Morlais Project

Terrestrial Ecology Assessment Update

Document Reference: MMC353 MOR-RHDHV-DOC-0110 (4)

Updated assessments for terrestrial ecology (excluding chough) in response to comments made on the Environmental Statement by NRW and RSPB – version 04

Figure: 1

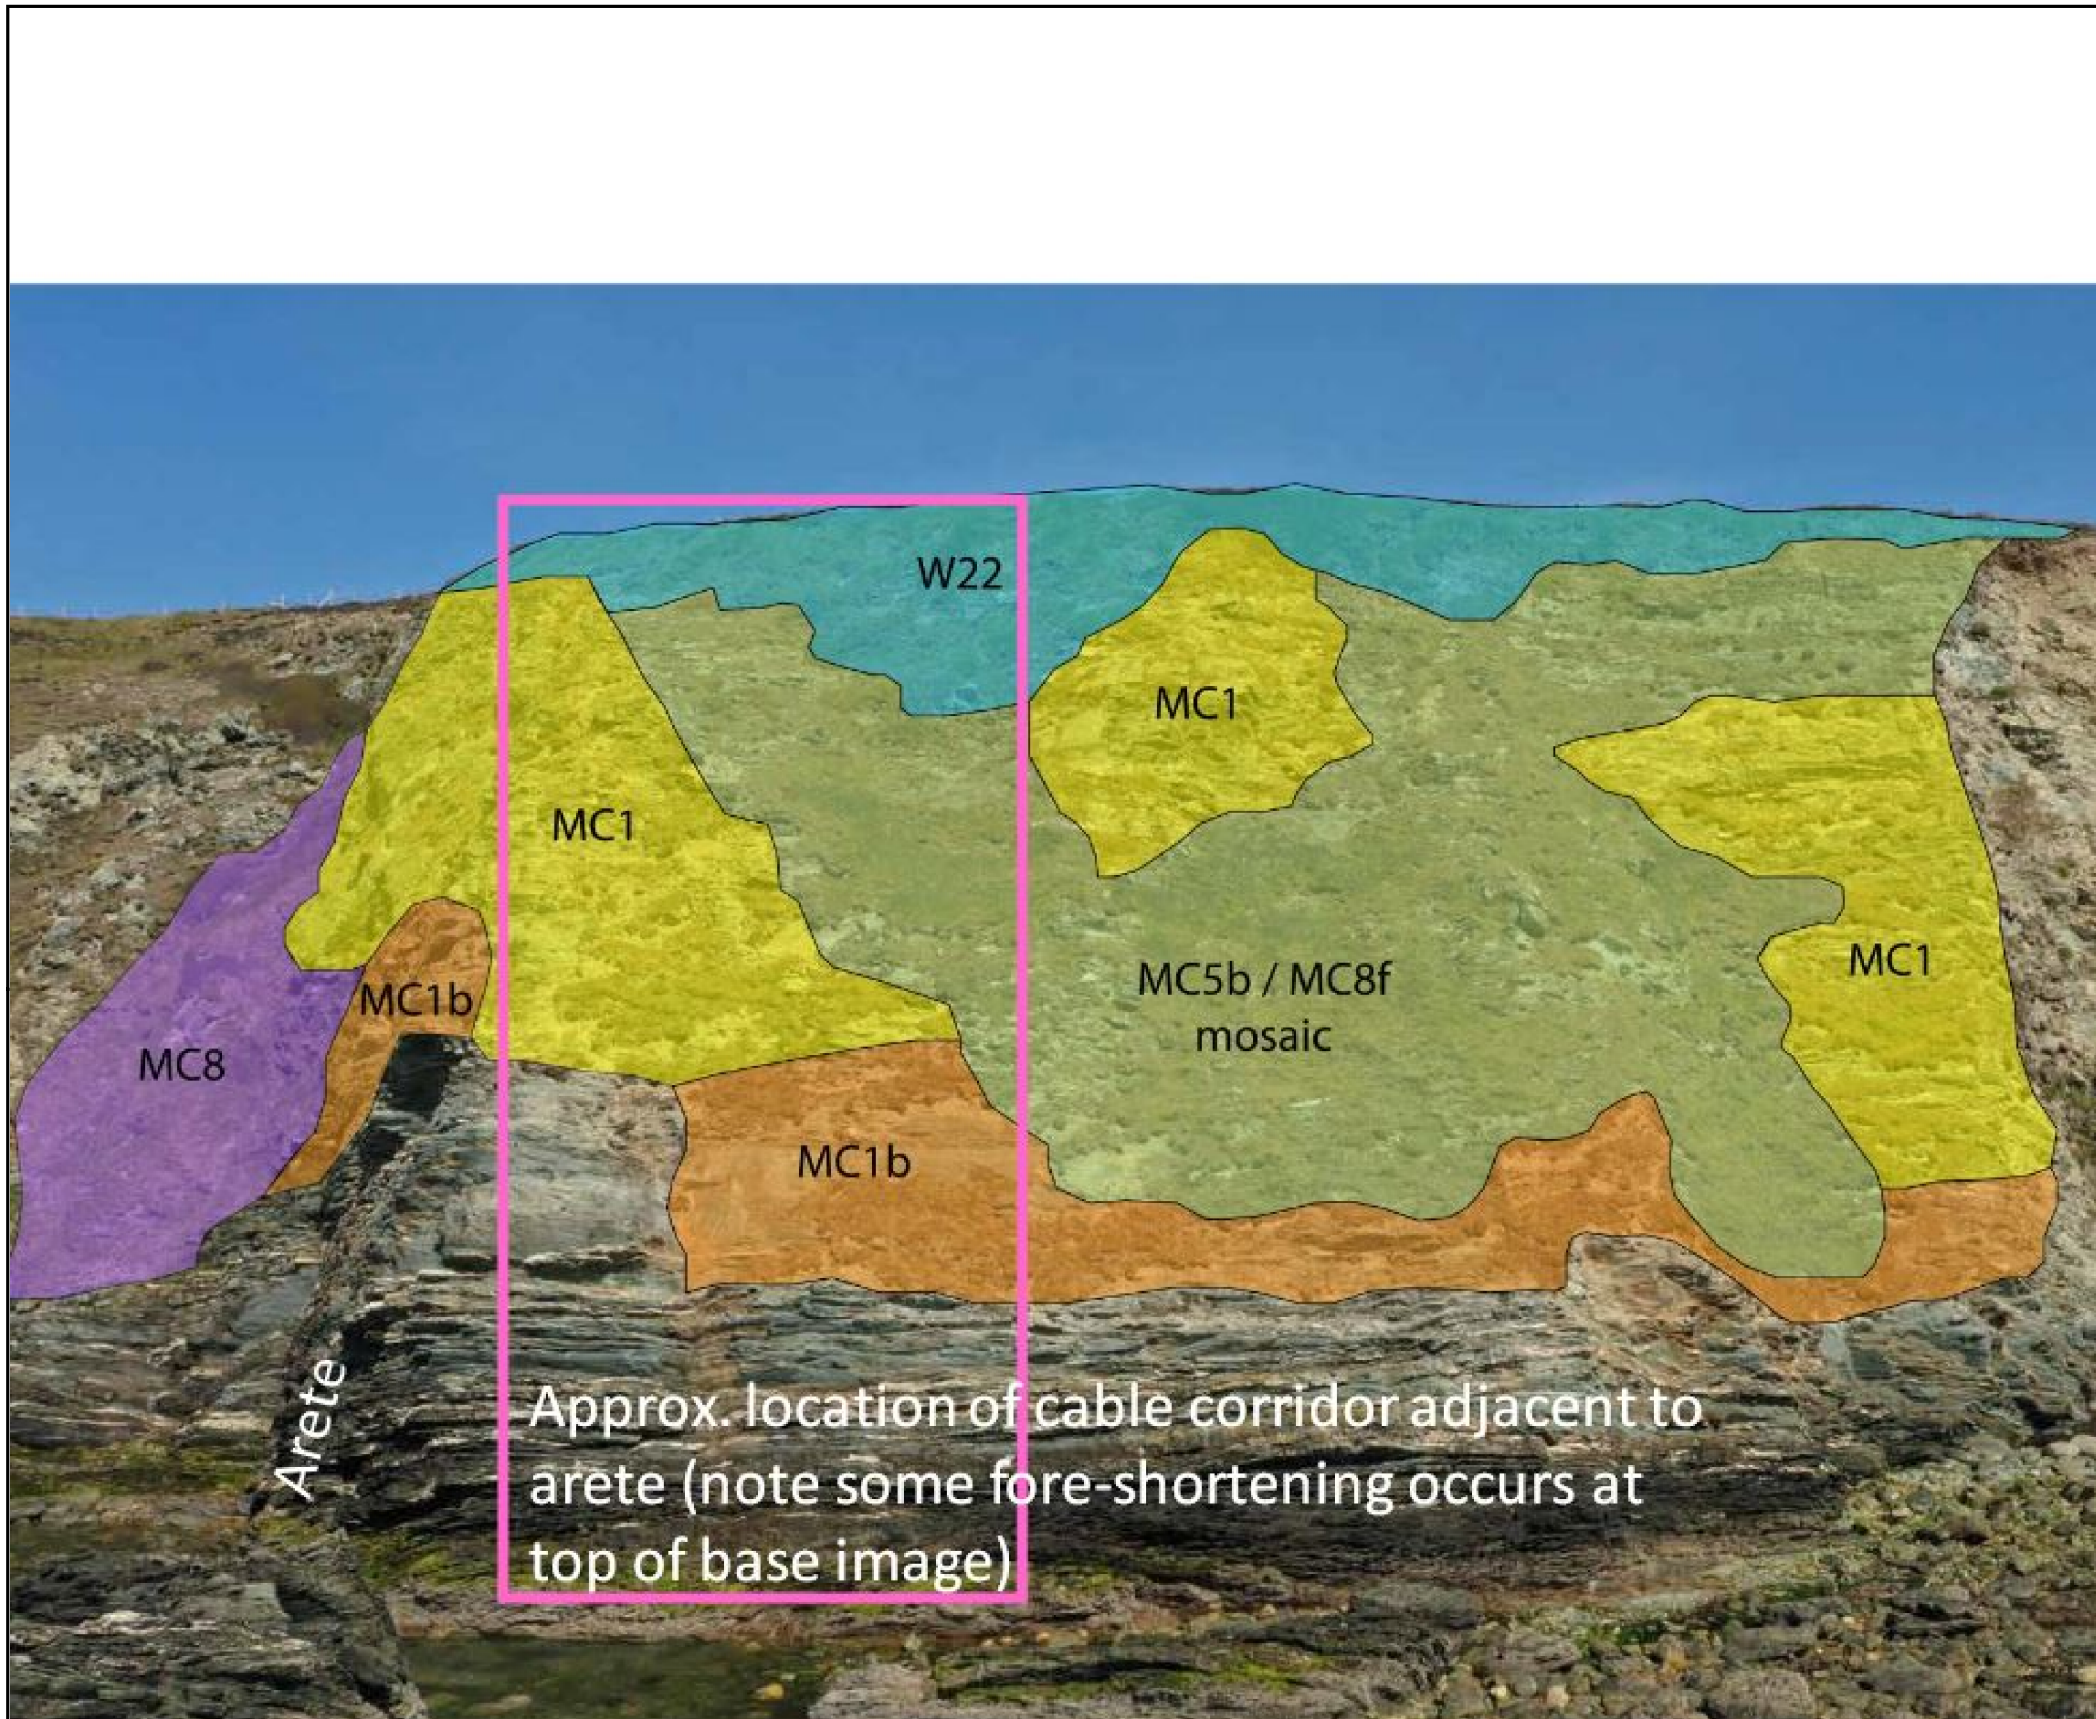
19	We would seek clarity over the reasons why Option A has been selected over Options B and C, as from Figure 1 it appears that a larger area of vegetated vertical sea cliff would be affected compared to Option C and to a lesser extent Option B. We would value seeing the process and reasons as to why Options B and C have been ruled out.	The project engineers (Black & Veatch) determined that Option A has the greatest stability for allowing the engineering of pinning the cables to cliff.

Comment Number	Comment Detail	Morlais Response
		Options B and C were discounted prior to application due to significant areas of fractured rockface (B) and access restrictions for construction machinery / proximity to only public right of way to beach (C). Both Options B and C would also require impacting a larger section of cliff and vegetation than Option A. A is the most stable area for pinning the cables to.
20	It is difficult to anticipate what the effects of the J- tubes 400mm from the cliff will be. During installation we would expect almost all vegetation within the working zone to be damaged, but roots may persist and may regrow. We will have a better idea about how fragile the vegetation is after the survey.	Assessment assumes worst case of all being removed for the life of the project (>40yrs), although the methodology proposed has been designed to minimise loss of vegetation if at all possible. (See Sections 5 and 6).
